LiDAR Quality Assessment Report

WA_ElwhaRiverLidar_2012

Lot 5 of 6 lots.

Project Tiling Scheme:

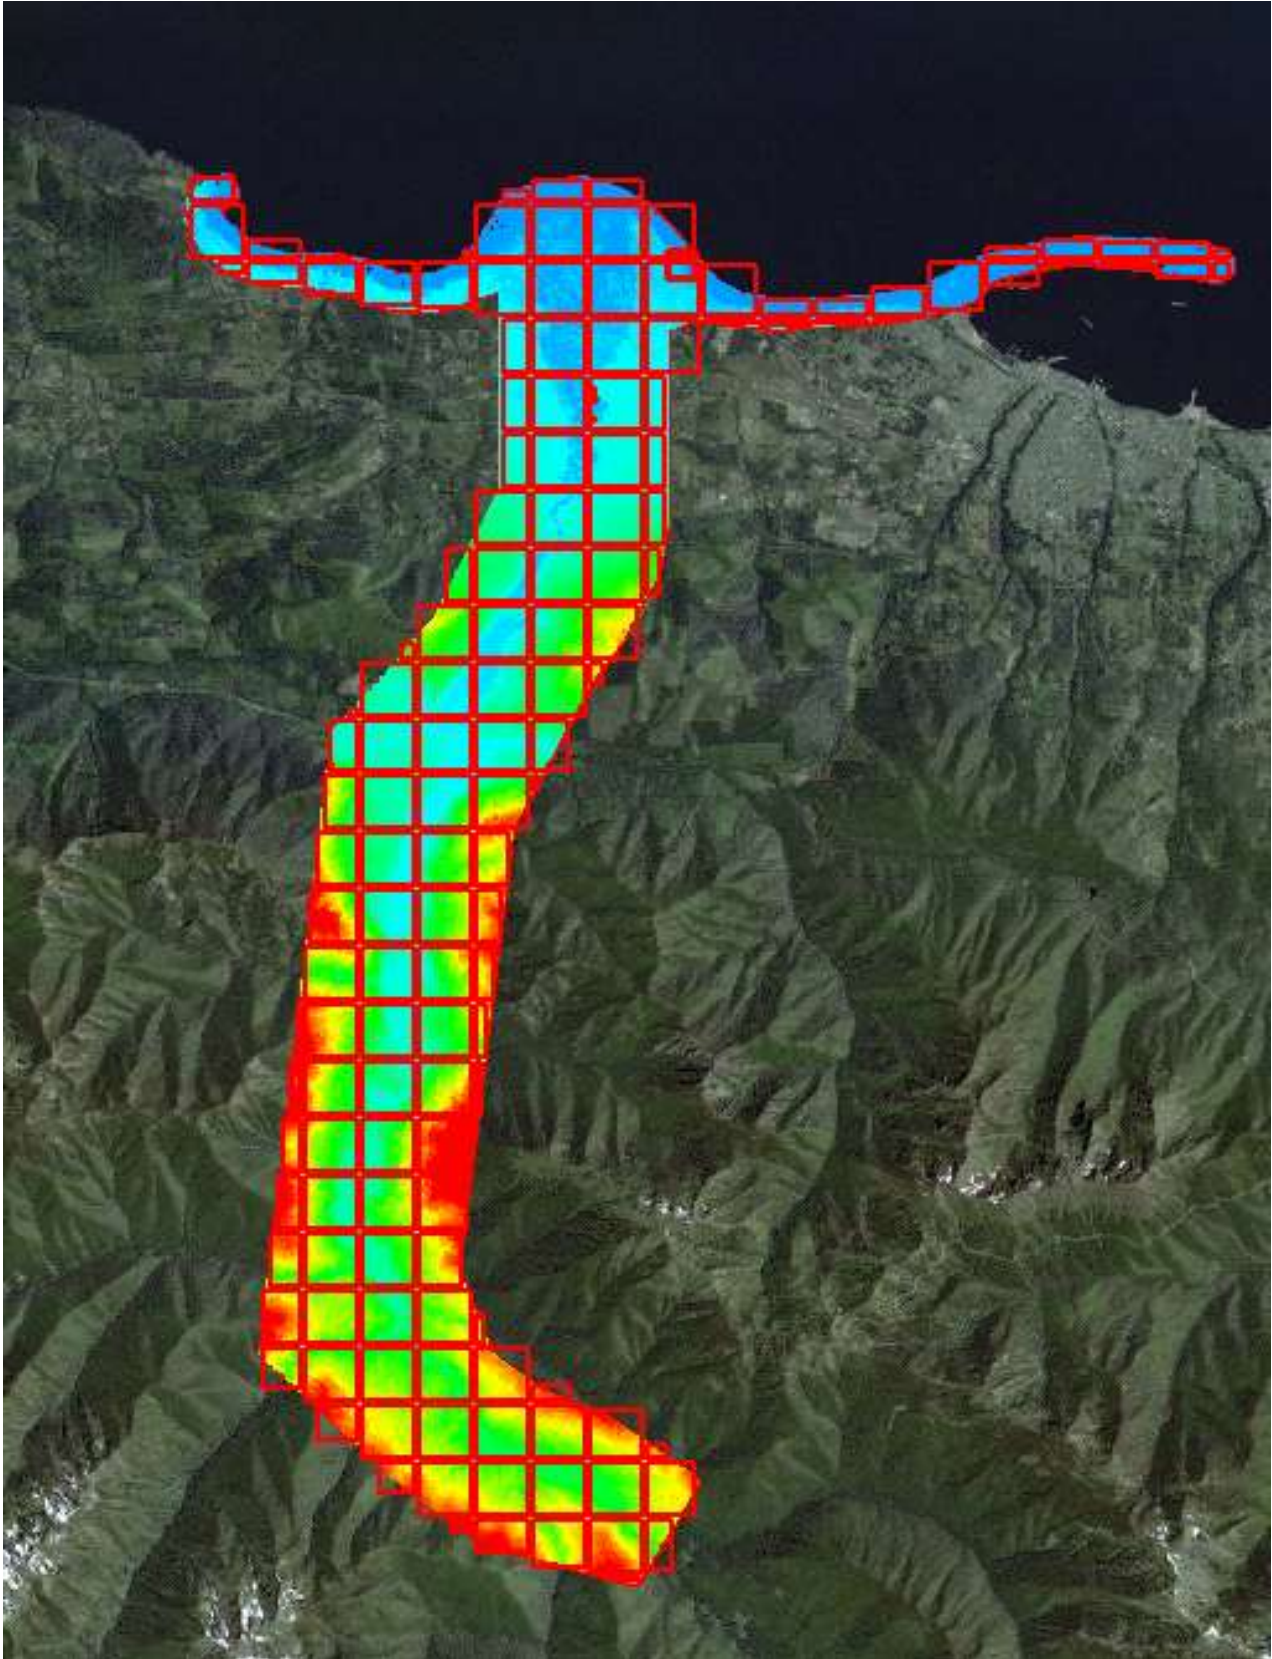
The tiling system specified in the Task Order was for 1500m X 1500m however the tiling system is 1000m X 1000m. I do not see this as a reason to reject the LAS files.

The task order designated 1500m x 1500m tiles and the delivered tiles are 1000mx1000m.

I have accepted the Elwha River Lidar dataset unless others feel the tile size discrepancy is reason for rejection and reprocessing.
